State of New Mexico
Energy, Minerals and Natural Resources

OIL CONSERVATION DIVISION
1220 South St. Francis Dr.
Santa Fe, NM 87505

WELL API NO. 30-015-22307
5. Indicate Type of Lease STATE [X] FEE [ ]
6. State Oil & Gas Lease No.
7. Lease Name or Unit Agreement Name Bogle State Com
8. Well Number #1
9. OGRID Number 013837
10. Pool name or Wildcat Diamond Mound; Upper Penn (G)
11. Elevation (Show whether DR, RKB, RT, GR, etc.) 3578'

SUNDRY NOTICES AND REPORTS ON WELLS
(DO NOT USE THIS FORM FOR PROPOSALS TO DRILL OR TO DEEPEN OR PLUG BACK TO A DIFFERENT RESERVOIR. USE "APPLICATION FOR PERMIT" (FORM C-101) FOR SUCH PROPOSALS.)
1. Type of Well: Oil Well [ ] Gas Well [X] Other [ ]
2. Name of Operator Mack Energy Corporation
3. Address of Operator P.O. Box 960 Artesia, NM 88210
4. Well Location
Unit Letter I : 2560 feet from the N line and 660 feet from the E line
Section 2 Township 16S Range 27E NMPM County Eddy

Mack Energy			
Author:	BCM & Associates, INC		
Well Name	Bogle State Com	Well No.	#1
Field	Diamond Mound	API #:	30-015-22307
County	Eddy	Lease #	
State	NM	Location	Sec 2, T16S, R27E
Spud Date	10/22/1977		2650' FNL & 660' FEL
GL	3578'

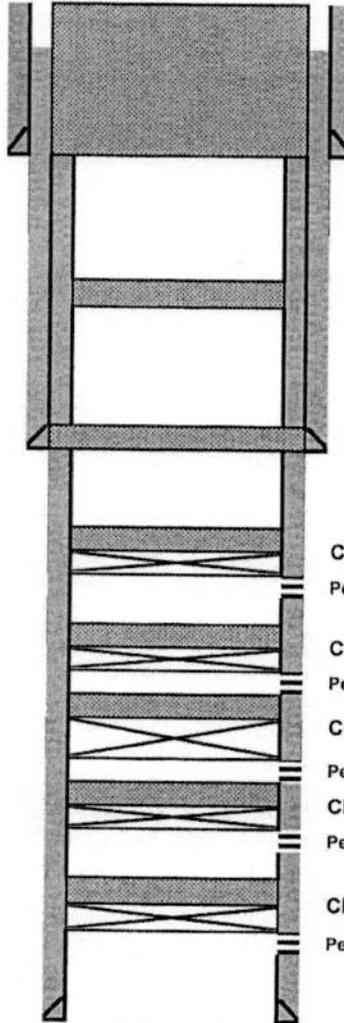
- 1. Tag existing 4 1/2" CIBP @ 2796' w/ 35' cmt on top. Circulate hole w/ MLF. Pressure test csg.
2. Perf & Sqz 30 sx cmt @ 1682-1480'. WOC & Tag (8 5/8" Shoe & San Andres)
3. Not [X] sx cmt @ 855-655'. WOC & Tag (Queen & T/Salt) Perf @ 855' and sqz 25 sx cmt. WOC & tag
4. Perf & Sqz 60 sx cmt @ 395' & circulate to surface.
5. Cut off well head, verify cmt to surface, weld on Dry Hole Marker.

3. Spot 15 sx cmt @ 855-655'. WOC & Tag (Queen & T/Salt)
